CITY OF ALBUQUERQUE

RE: SAD 228, Lot 7 Block 10 6509 Petirrojo Rd. NW Grading and Drainage Plan Engineers Stamp Date 12/8/14 (D10-D003P7)

Development, Inc. 8860 Desert Finch Ln NE Albuquerque, NM 87122 (505) 280-4553 GRADING AND DRAINAGE PLAN

Grading and Drainage Plan Engineers Stamp Date 11/29/14 (D10-D003P7)

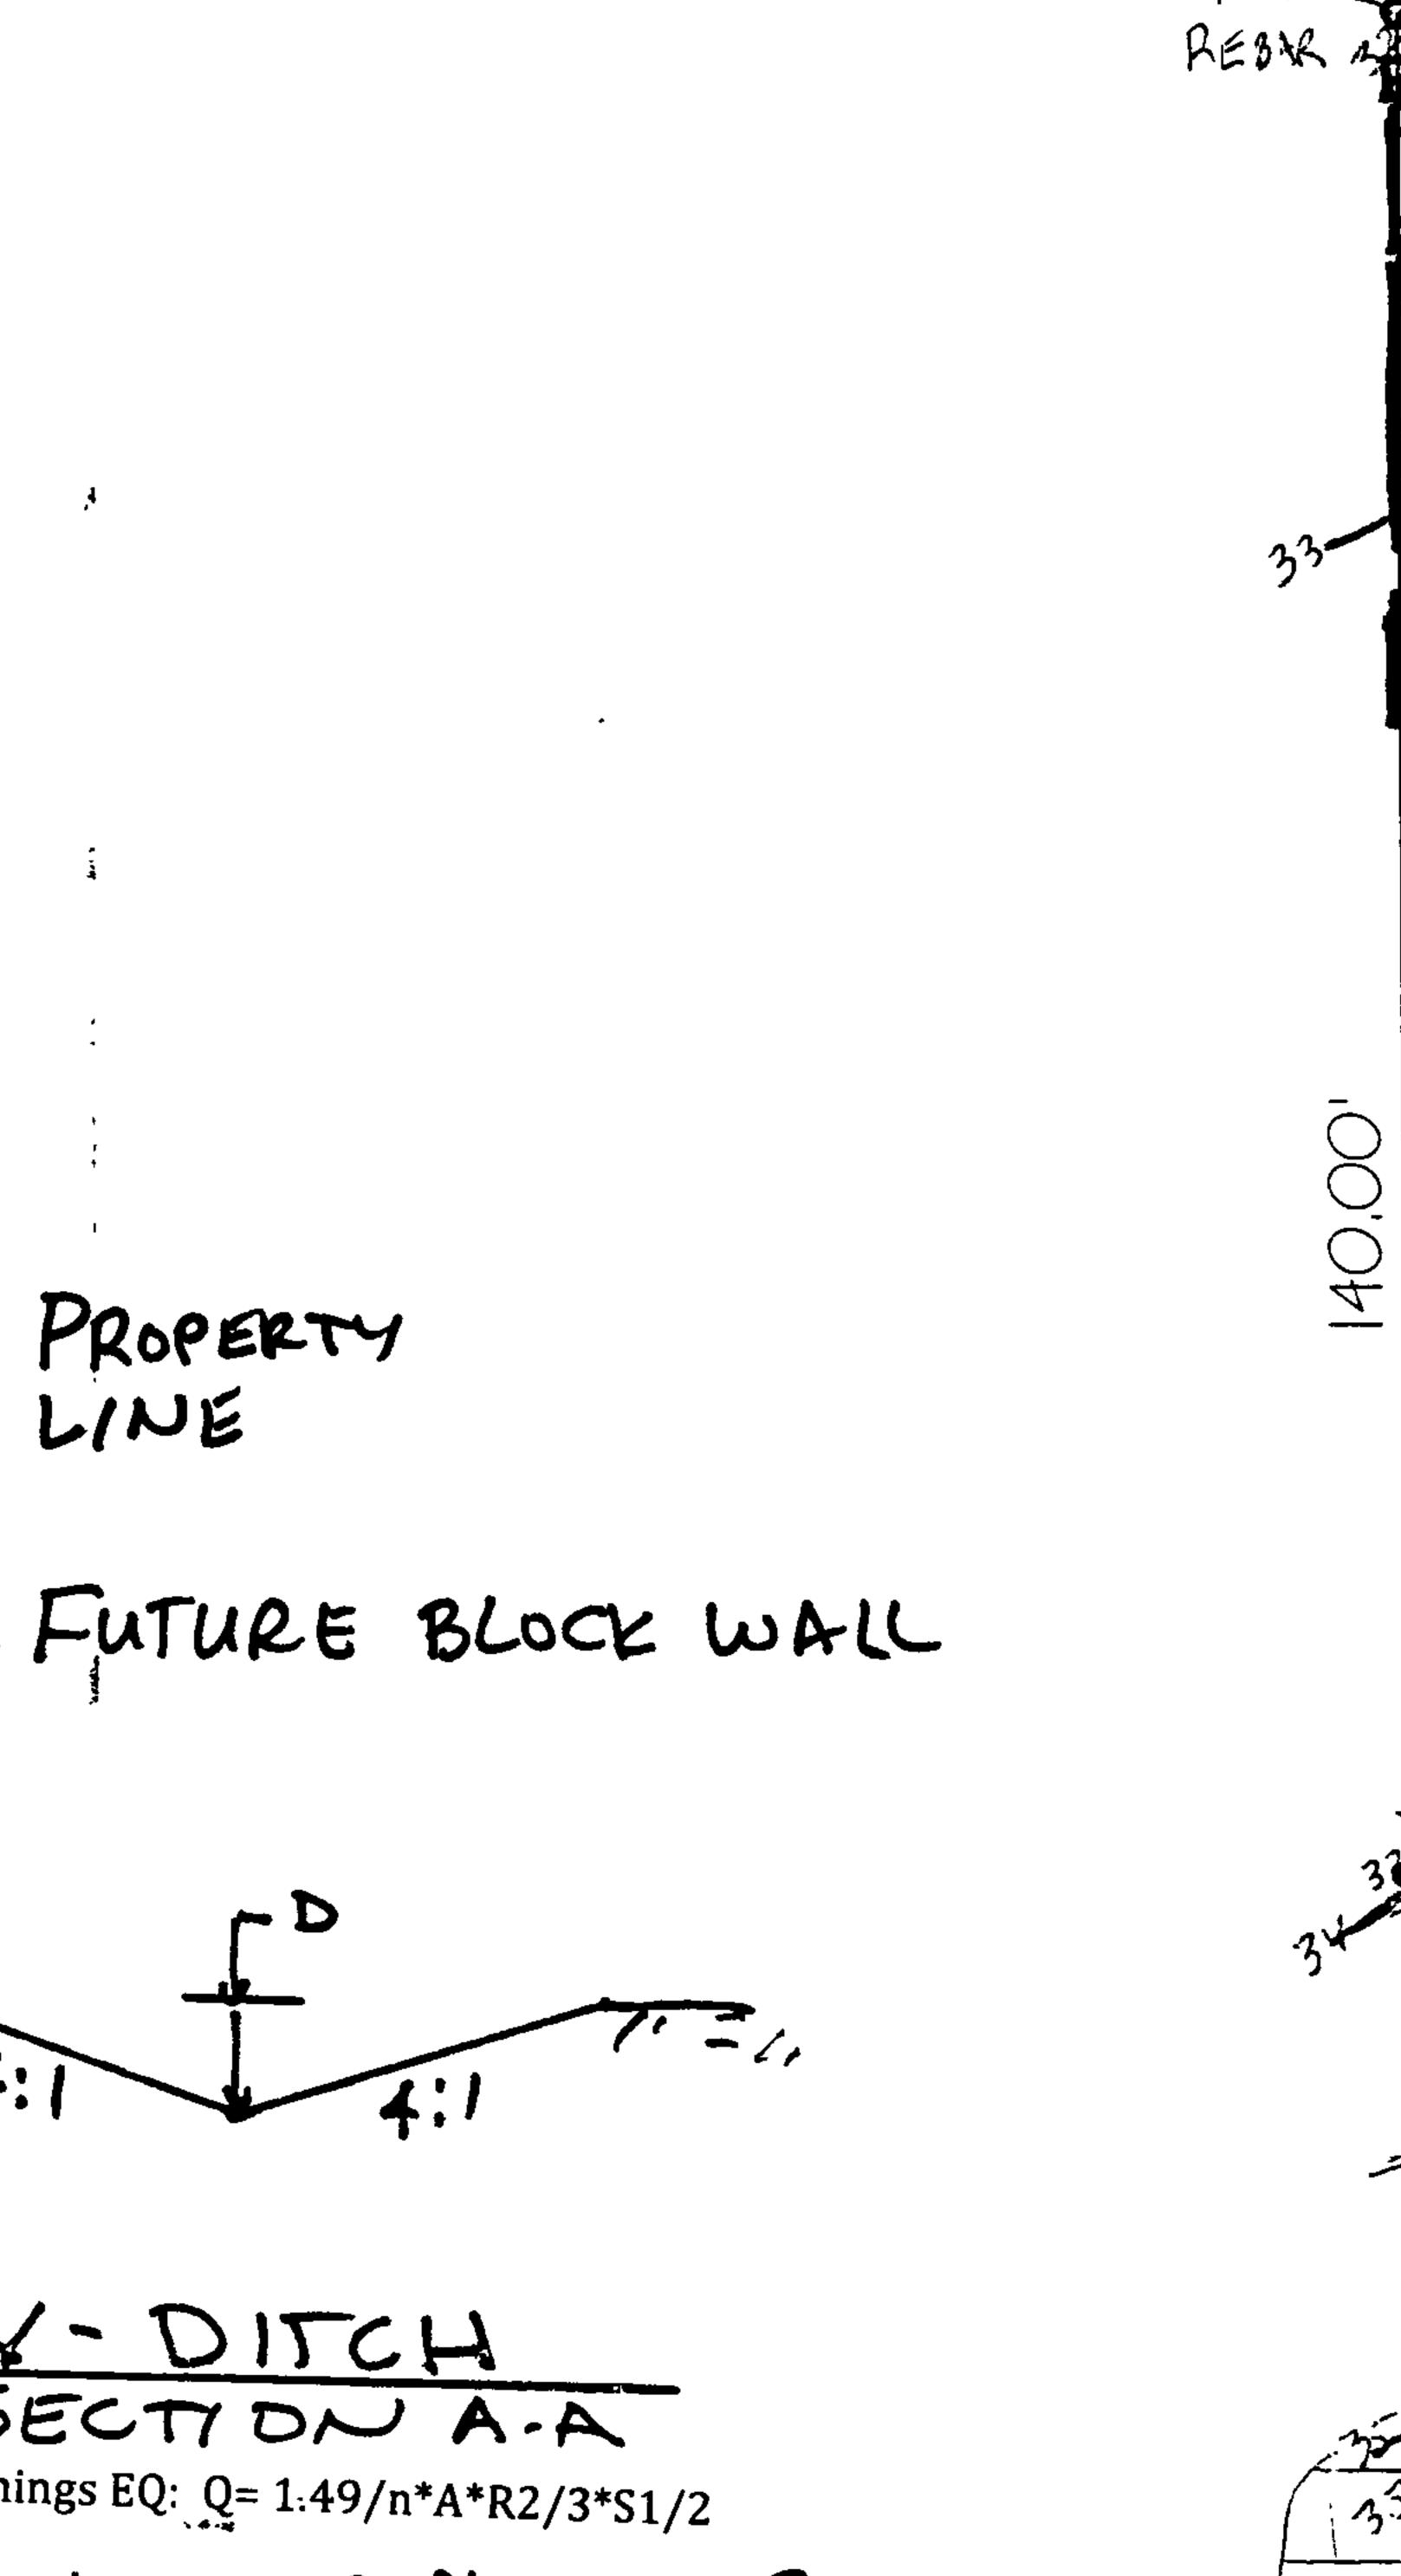
- Provide a Vicinity map, a FEMA map or designation, a narrative.
- Mention of the first flush per EPA standards is required. The amount required is .34" times the impervious area.
- Provide a section of the V Ditch and calculations for the ditch. 13.0cfs seems a bit too much. Is the ditch a shared ditch, if so where will the block fence be placed?
- What are the inverts of the openings? Is this a block fence? Future
- What is the flow line in the street?

- Provide a Vicinity map, a FEMA map or designation, a narrative.
- Mention of the first flush per EPA standards is required. The amount required is .34" times the impervious area.
- Provide a section of the V Ditch and calculations for the ditch. 13.0cfs seems a bit too much. Is the ditch a shared ditch, if so where will the block fence be placed?
- What are the inverts of the openings? Is this a block fence?
- What is the flow line in the street?

The Initial First Flush to be manages is 0.44" less 0.10" initial impervious abstraction = 0.34" or 480 cubic feet. The initial storage on site will be collected and held in the two landscape ponds near the street as shown on the Plan.

Y-DITCH SECTION A.A Mannings EQ: Q = 1.49/n*A*R2/3*S1/2

D:0.6' S=0.90% n=003 Qios: 2.5 cfs Vioo = 1.7 fps
